# Appendix A

## NOP and Scoping Comments

**Fenton Parkway Bridge Project**

### Fenton Parkway Bridge - Comments to 30% Plans and Type Selection

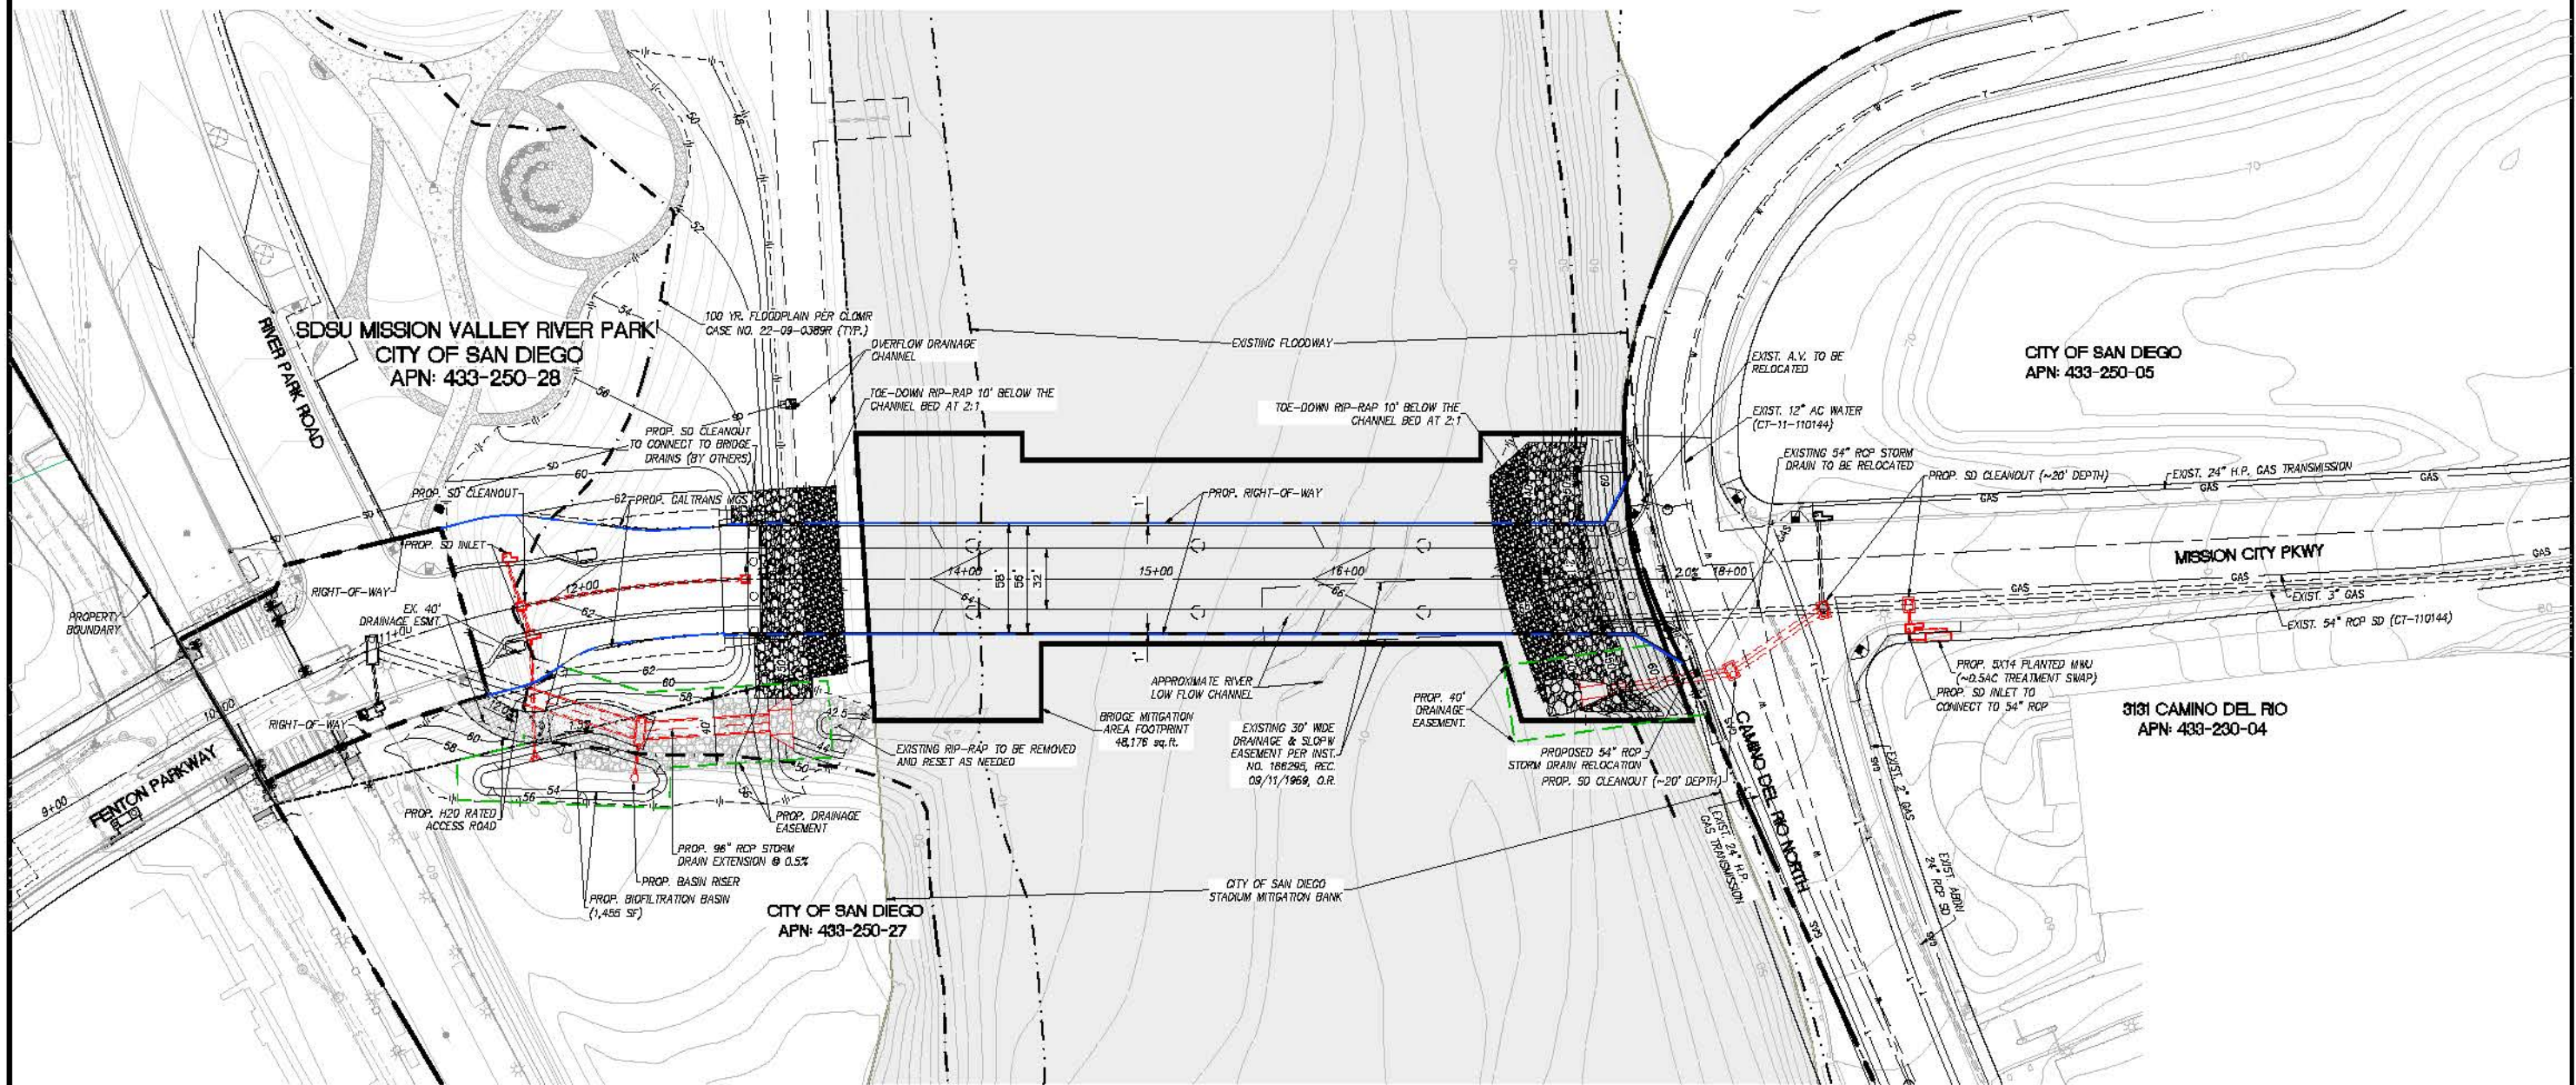
Name	Department	Comment	Response
Jakubauskas, Jerry	Engineering & Capital Projects	<ul style="list-style-type: none"> <li>-The only issue is the proposed use of on-bridge standard cobra head light fixtures mounted on concrete pedestals. Because the proposed bridge spans the San Diego River and MHPA, an alternative light standard that is shielded and directed onto the bridge deck with minimal to no spillover onto the SD River and MHPA will most likely be required by MSCP and/or resource agencies.</li> </ul>	
Gardiner, Maureen	Sustainability and Mobility Department	<ul style="list-style-type: none"> <li>-During flooding when no other roads that cross the river are passable (only the freeways) the statement about “alternate emergency roads are available” may not apply. In addition, during those times (flooding), or potentially during events the road may be operated with the center painted median as an additional travel lane.</li> <li>-7.3 Approach Slabs</li> <li>-No concrete approach slabs are proposed for the Fenton Parkway Bridge. Following the flow chart for</li> <li>-asphalt concrete approaches in Caltrans Memo to Designers 5-3 Attachment B:</li> <li>-This is not a multilane urbanized highway facility</li> <li>-Peak rock acceleration is less than 0.6g, but liquefaction and lateral spreading are seismic risks,</li> <li>-albeit mitigable using ground improvement</li> <li>-Alternate emergency roads are available</li> <li>-Therefore, concrete approach slabs are not necessary.</li> <li>-The intention is for this bridge to be an all-weather roadway so although it seems obvious that it exceeds typical flooding events in the valley, it would be worth mentioning what threshold it does meet or exceed on the plans and in the study. IE 100-year flood, 500-year, etc.</li> </ul>

Forburger, Kristen	Planning Department	<ul style="list-style-type: none"> <li>-Lighting -All lighting within or adjacent to the MHPA is directed away/shielded from the MHPA, or limited to the immediate area and is in compliance with City Outdoor Lighting Regulations per LDC Section 14.2.0740.</li> <li>-Bridge construction shall be planned and scheduled to avoid avian nesting season of Federally endangered Least Bell's vireo as the area is currently occupied by the species. A Section 7 consultation and biological opinion will be required by USFWS. Project implementation shall avoid impacts to federally listed species.</li> <li>-The proposed project shall include analysis consistent with the City of San Diego Land Development Code Environmentally Sensitive Lands Essential Public Projects (EPP) Option:</li> <li>-Deviations from wetland requirements in ESL will be considered under the EPP Option when a proposed project(s) meets all the following criteria. The project must be an EPP (i.e., circulation element road, trunk sewer, water main) that will service the community at large and not just a single development project or property. The project must meet the definition of an EPP as identified in Section IV and must be essential in both location and need. If the City has options on the location of an EPP, the City should not knowingly acquire property for an EPP which would impact wetlands.</li> <li>-The proposed project and all biological alternatives, both practicable and impracticable shall be fully described and analyzed in an appropriate CEQA document. Alternatives to the proposed project shall be comprehensively included in the CEQA document (e.g., Mitigated Negative Declaration) and/or the biological technical report for the CEQA document. Alternatives must include the following: 1) a no project alternative; 2) a wetlands avoidance alternative, including an analysis of alternative sites irrespective of ownership; and 3) an appropriate range of substantive wetland impact minimization alternatives. Public review of the environmental document must occur pursuant to the provisions of CEQA.</li> <li>-The potential impacts to wetland resources shall be minimized to the maximum extent practicable and the project shall be the least environmentally damaging practicable biological alternative considering all the technical constraints of the project (e.g., roadway geometry, slope stability, geotechnical hazards, etc). Recognizing the wetland resources involved, minimization to the maximum extent practicable may include, but is not limited to, adequate buffers and/or designs that maintain full hydrologic function and wildlife movement (e.g., pipeline tunneling, bridging, Arizona crossings, arch culverts). The project applicant will solicit input from the U.S. Fish and Wildlife Service and the California Department of Fish and Wildlife (e.g., Wildlife Agencies) prior to the first public hearing.</li> </ul>
